TYPE NO FB7300	TYPE Coffe Vending Machines	T.I. NO 2012_08				
SERIAL NUMBERS AFFECTED From and including S/N 21111862	ISSUED BY Documentation/N&W Valbrembo					
SUBJECT <u>HOLDER FOR DRIP CATCHER</u>		ISSUED FOR (X): <table border="1"> <tr> <td>Action</td> <td></td> </tr> <tr> <td>Information</td> <td>X</td> </tr> </table>	Action		Information	X
Action						
Information	X

HEADLINE

In all the FB73000 machines the clamping of cover for scraper, 1 hexagonal bushes with metric screw thread and a knurl.

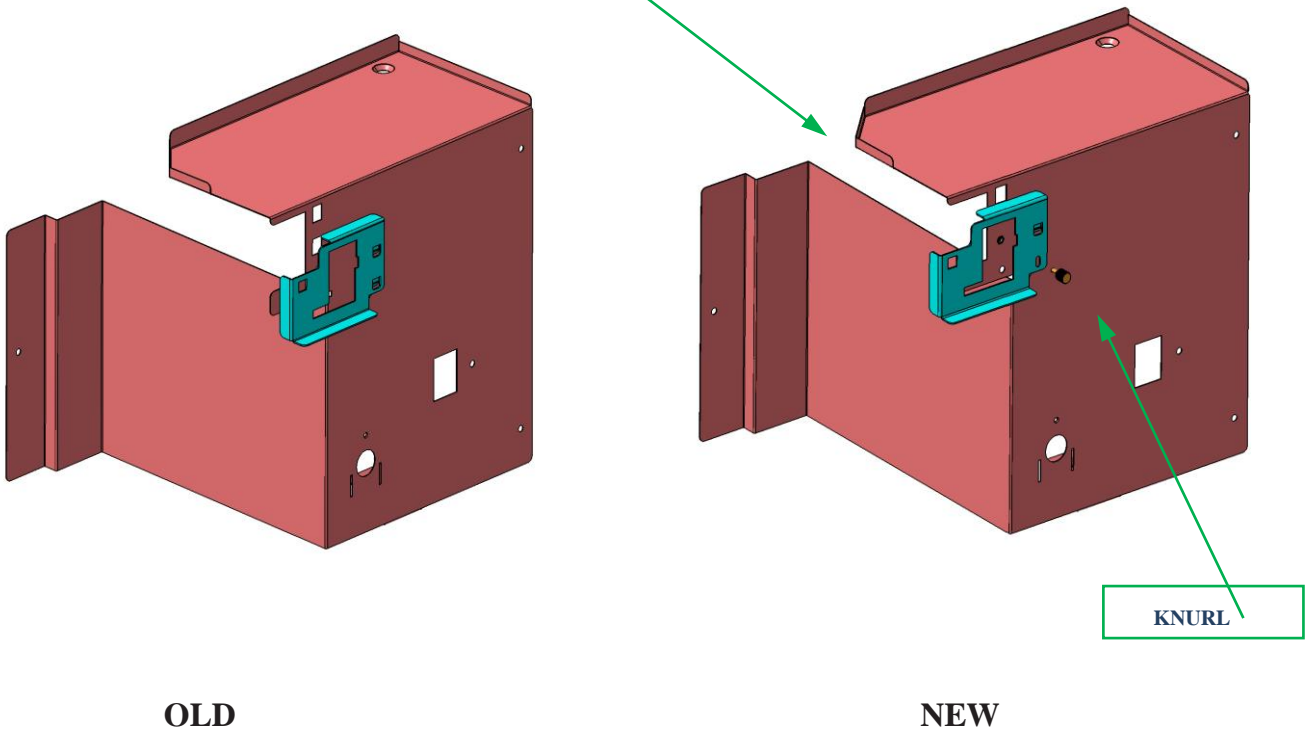
- ✓ Knurl
- ✓ Holder for drip catcher
- ✓ New boiler cover

Introduced a modified boiler cover, a new hexagonal bushes with metric screw thread and knurl.

In order to improve the fixation of the holder for the drip tray catcher and to avoid the metal part comes loose from the boiler cover with the results of branch pipe errors.

The 2 new parts are 100% replaceable.
